**To:** Historic Landmarks Board

**Re:** February 27 Agenda

# Mock Historic Landmark Review Staff Report and Recommendation

**Report Date:** February 20, 2018  
**Hearing Date:** February 27, 2018  
**Request:** Commercial Remodel including removal of an existing storefront and the installation of new masonry, new windows and doors, and a new steel canopy  
**File Number:** 311-18-00001X-PLNG  
**Property Location:** 1234 Main Street  
**Legal Description:** Washington County Tax Lot 1S3 6BB-100000  
**Applicant:** George Cushing, QUE Construction, Inc.  
2700 SE 35<sup>th</sup> Circle - Suite A, Portland, Oregon 97222  
**Comprehensive Plan and Zoning Map Designations:** Town Center Core (TCC)  
Town Center Core (TCC)  
**Applicable Standards and Criteria:** City of Forest Grove Development Code:  
§10.5.220 *Procedure for Review of Proposed Work Affecting the Exterior of Landmarks*

EXTERIOR ELEVATIONS

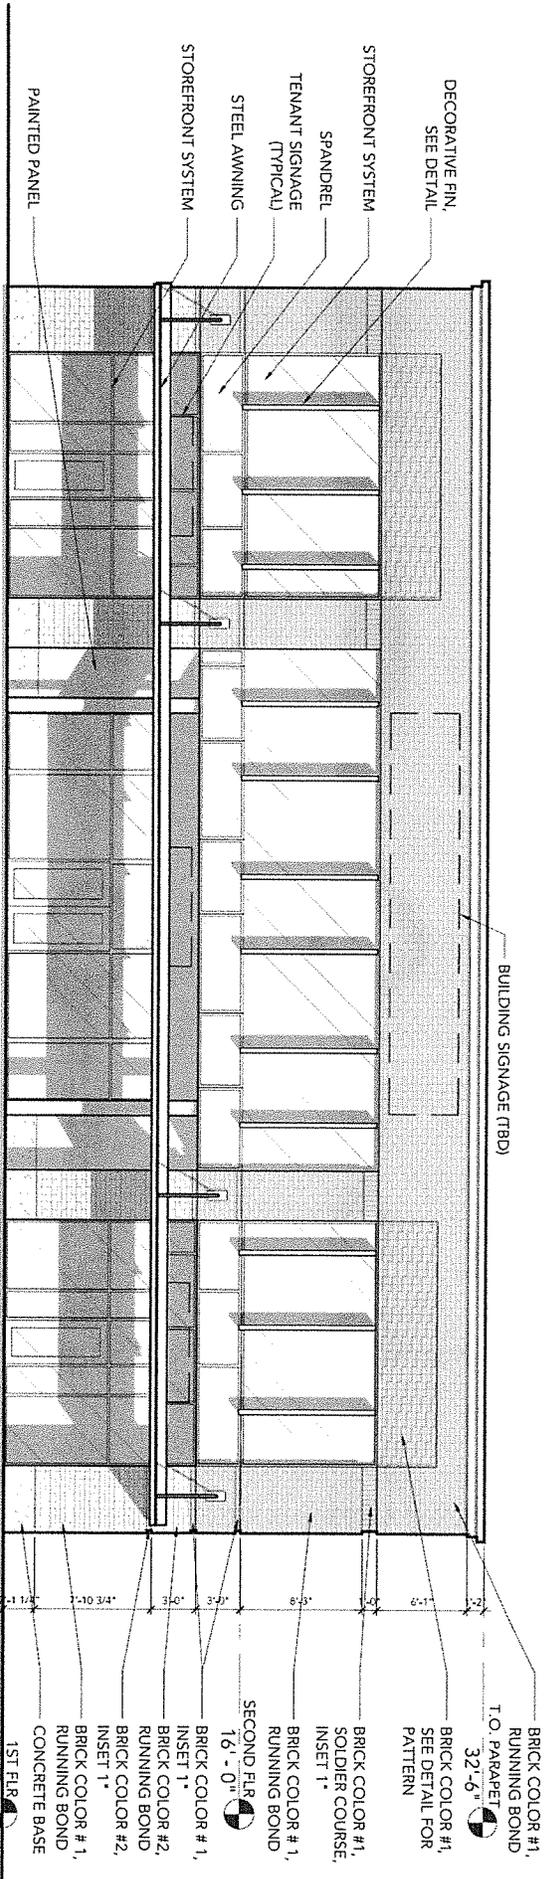
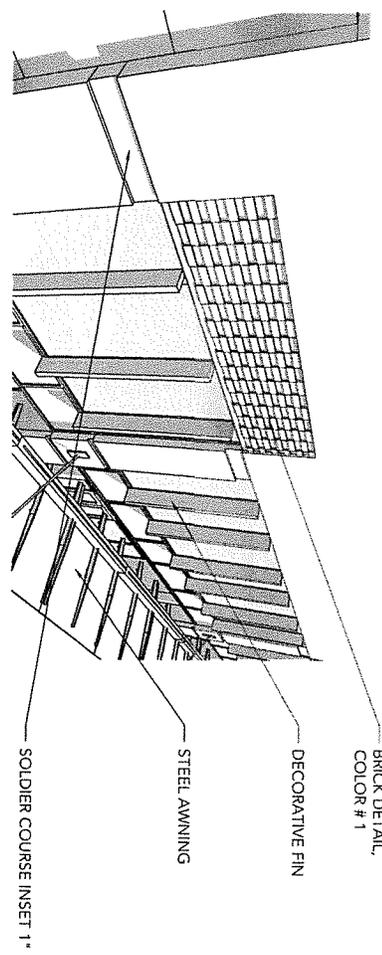
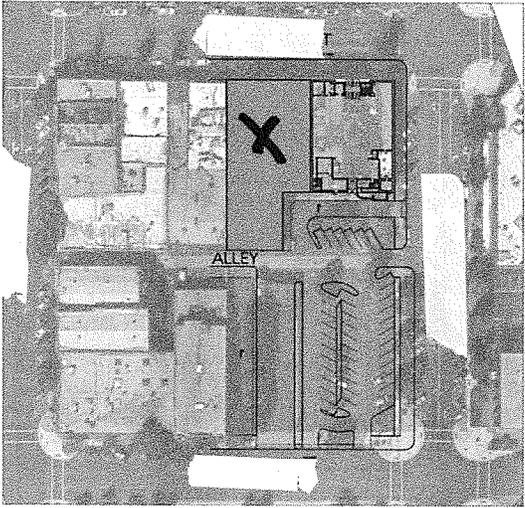
- Entirely removing the existing Main Street façade.
  - Construction of an entirely new façade, including all new brick, a new ground floor storefront system, and a new steel awning (see Exhibit A Sheet A-2 Exterior Elevations).
- B. Site Examination: The building is sited mid-block on Main Street. The entire site is occupied by the building. Main Street has been fully improved to City standards.
- C. Preservation Briefs: The National Park Service has prepared a series of Preservation Briefs. *Rehabilitating Historic Storefronts* addresses new storefronts as follows (see Exhibit C for the entire brief):

*Finding: The aluminum siding and the anodized aluminum storefront are distinctive stylistic features of a 1950s-60s era commercial facade. The request, if approved, would replace the current façade with one more representative of the 1920s era when the building was originally constructed.*

*Finding: The architecture and materials used on the existing façade are representative of those used on 1950s-1960s storefronts. The request, if approved, would remove these historic features.*

1. The applicant shall be bound to the project description and all representations made by the applicant during the application and decision-making proceeding.
2. The applicant shall comply with all applicable City building codes and standards.
3. Requests for architectural modifications or a different selection of materials shall be reviewed by the HLB prior to construction.
